UNITED STATES PATENT AND TRADEMARK OFFICE

10/695,068

Office Action Summary	Application No. 10/695,068	Applicant(s) YOUNG ET AL.	
	Examiner STEVEN J. COTRONEO	Art Unit 3733

DETAILED ACTION

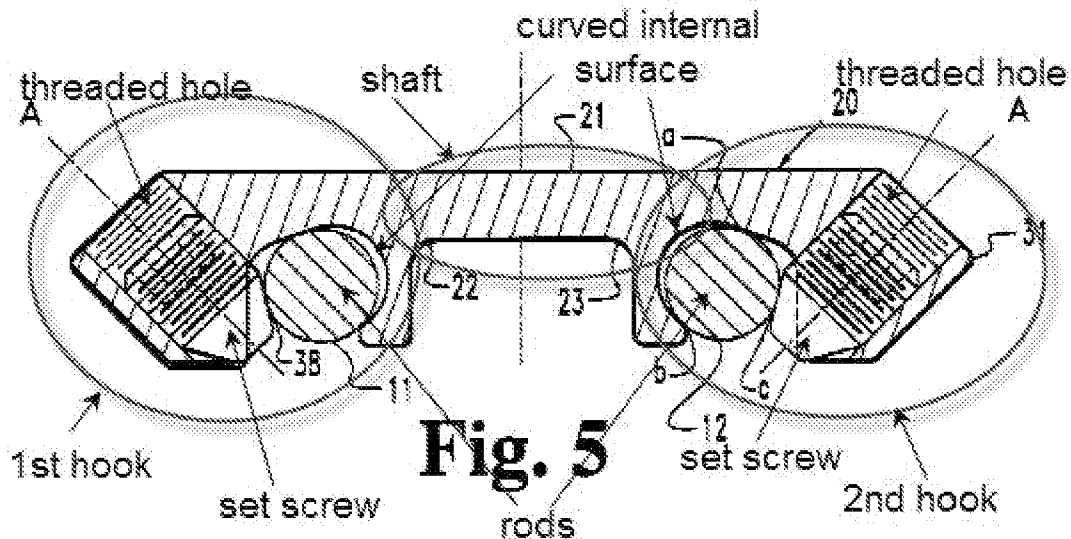
Hoeck et al. discloses a vertebral support apparatus (see fig 5 below), the apparatus comprising: first and second spinal rods (fig 5, 11 and 12); a solid non-hollow shaft (fig 5, 21) the shaft is solid across the entire cross-section of the shaft and includes no internal cavity. A first hook (see fig 5 below) including a first internal surface has a curved portion, the first rod contacting the first internal surface. A second hook (see fig 5 below) including a first end unitary and integral with the shaft at a position axially displaced from the first hook, the second hook terminating at a second end spaced laterally from the shaft and comprising a second internal surface having a curved portion. The shaft includes a first threaded hole (see fig 5 below) associated with the first hook, and a set screw (fig 5, 38) extends through the first threaded hole contacting the first rod and forcing the first rod against the first internal surface. The shaft includes a second threaded hole (see fig 5 below) associated with the second hook. The shaft defines a substantially planer plate (see fig 5 below). The apparatus is

formed as one piece and is a permanent and non-adjustable. **The rods form a rigid assembly (col. 1, ll. 30-35).**

Hoeck et al. does not disclose including a ridge extending along the curved portion in a direction from the first end to the second end.

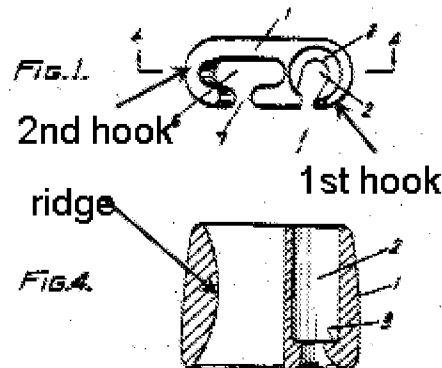
Faulkner discloses including a ridge (see fig 1 and 4 below) extending along the curved portion in a direction from the first end to the second end to allow for the opening in the hook to be large enough to easily insert the rod into the hook (col. 2, ll. 10-15). The ridge (fig 4, 6) is formed as first internal surface and a second internal surface that intersect in a first and second direction oblique direction (see fig 2E below). The ridge allows for the two rod to be placed in a non-parallel arrangement (fig 6).

It would have been obvious at the time of the invention to one of ordinary skill in the art to modify the device of Hoeck et al. with a ridge extending along the curved portion in a direction from the first end to the second end in view of Faulkner in order to allow the hook to be wide enough to allow for the rod to be inserted into the hook. **The rod is compressed against the ridge when the screw of Hoeck is inserted when the ridge is located in section a.**

The applicant also argues that the rod is not compressed against the ridge. Figure 4 above shows the portion the examiner is relying on to be the ridge and in figure 6 it is clear that the elongated member is located against the ridge. The applicant argues that the member is not against the crest of the ridge. This argument seems to be against the applicant's disclosure. Figure 28 shows the rod against the ridge in the current application. In Figure 28 the rod is not located on the apex of the ridge as the applicant is arguing but appears to be similar to figure 6 of Faulkner.

The applicant argues that rod is not against the crest of the raised ridge but located in the undercut. As stated above the length of figure 4 is the ridge and the rod of Faulkner is shown located as close to the crest as applicants own figures show.
